RE: Application for Air Construction Permit Modification and Associated Title V
Modification
Auburndale Power Partners, L.P.
Facility ID 1050221

RE: Application for Air Construction Permit Modification
Request for Additional Information
Auburndale Power Partners, L.P.
Facility ID 1050221

This letter follows our July 5, 2007 letter to request a minor modification to the Air Construction Permit (PSD-FL-185 and subsequent modifications) for the Auburndale Cogeneration Unit, owned by Auburndale Power Partners, L.P. (APP), and your subsequent request for additional information dated August 9, 2007. We are pleased to respond directly to the five items listed in your letter as follows here.

Figure 1 shows the total universe of data considered.

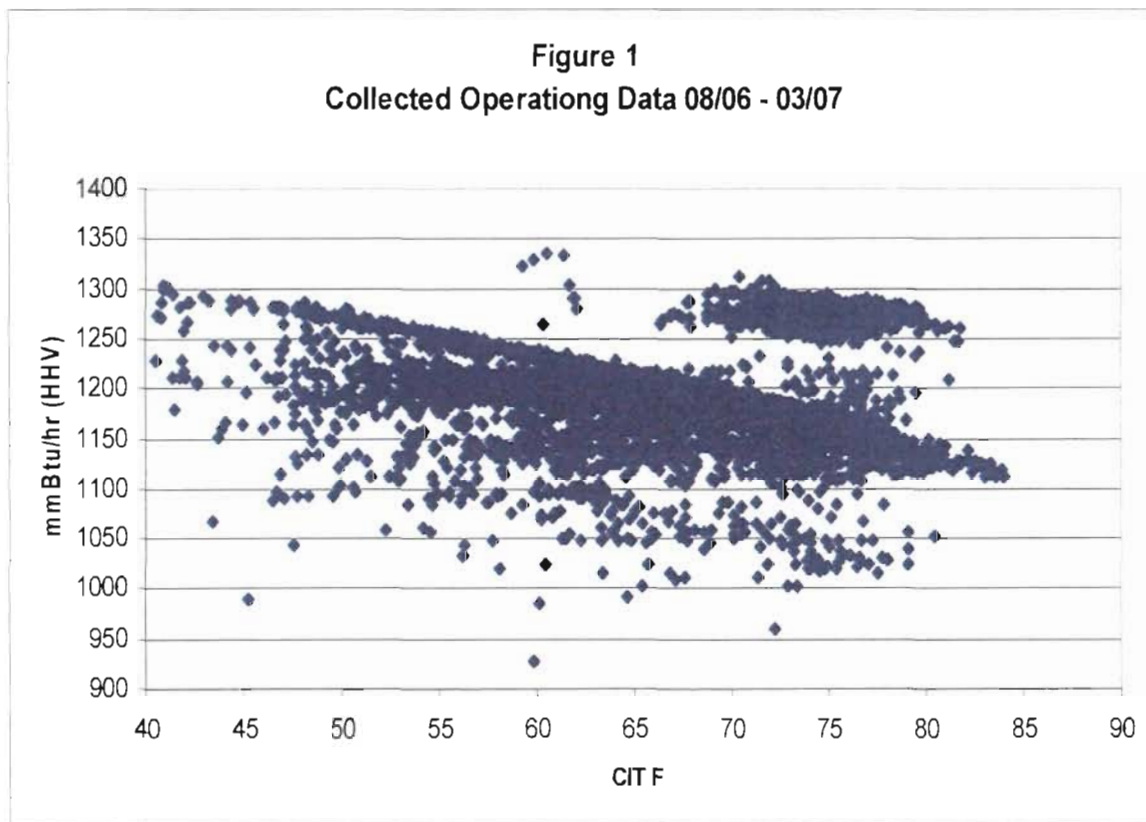
- 1. Please provide actual capacity information for the combined cycle gas turbine to support your request for an increase in the permitted heat input rate. Provide actual short-term heat input rates that validate the curve in Figure 1.*

As discussed in the July 5, 2007 letter, APP has analyzed a large quantity of operating data to confirm the basis for the operating curves with and without the operation of the wet compression system.

In our review, a total of more than 5,300 data points, each representing the average operating data for 30 minute increments between August 1, 2006 and March 31, 2007 were considered. The data was identified for operation of wet compression (water flow rate). A major unit overhaul also took place during this time period and this was reflected in the data segregation.

The figures below display the results of this data analysis. In addition, APP has provided as Enclosure 1, the correction curve supplied to DEP in the 1997 PSD permit (0150221-002AV) and as Enclosure 2, an engineering memorandum showing the methodology used to develop the data presented here. It should be noted that the correction curve

In this figure data is shown for a variety of operating conditions both before and after the overhaul. Baseload data collected after the overhaul forms the defined line along the upper edge of the main data group. Because of the effects of performance degradation, the pre-overhaul data forms a less defined data "cloud" below and around this.

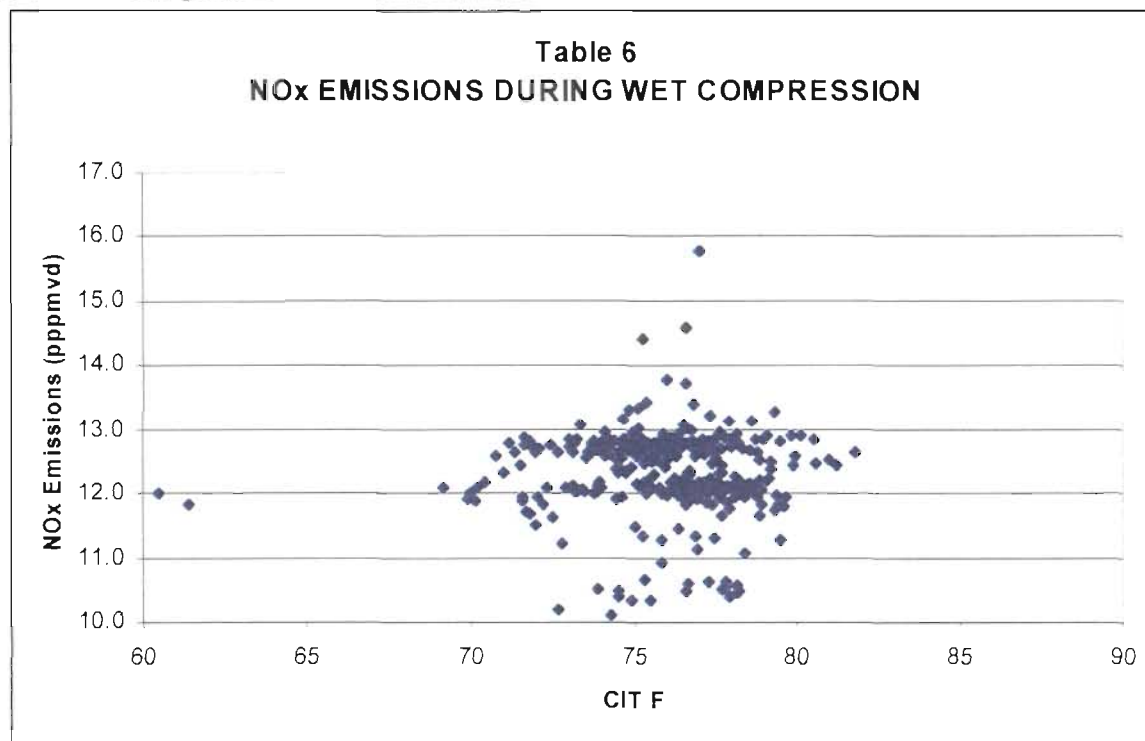
4. *Provide actual NOx data supporting operation at the increased heat input rate.*

Table 6 shows NOx emissions data for the same set of data shown in Figure 5. All data points except one are below the permitted emissions concentration limit of 15 ppmvd corrected to 15% O₂. Note that the data shown is for individual hours and is therefore indicative of the ability of the unit to meet the required emissions rate, not of specific compliance which is measured based on 24 hour averages. APP is not requesting any change in the pollutant emissions concentrations or mass emissions rates.
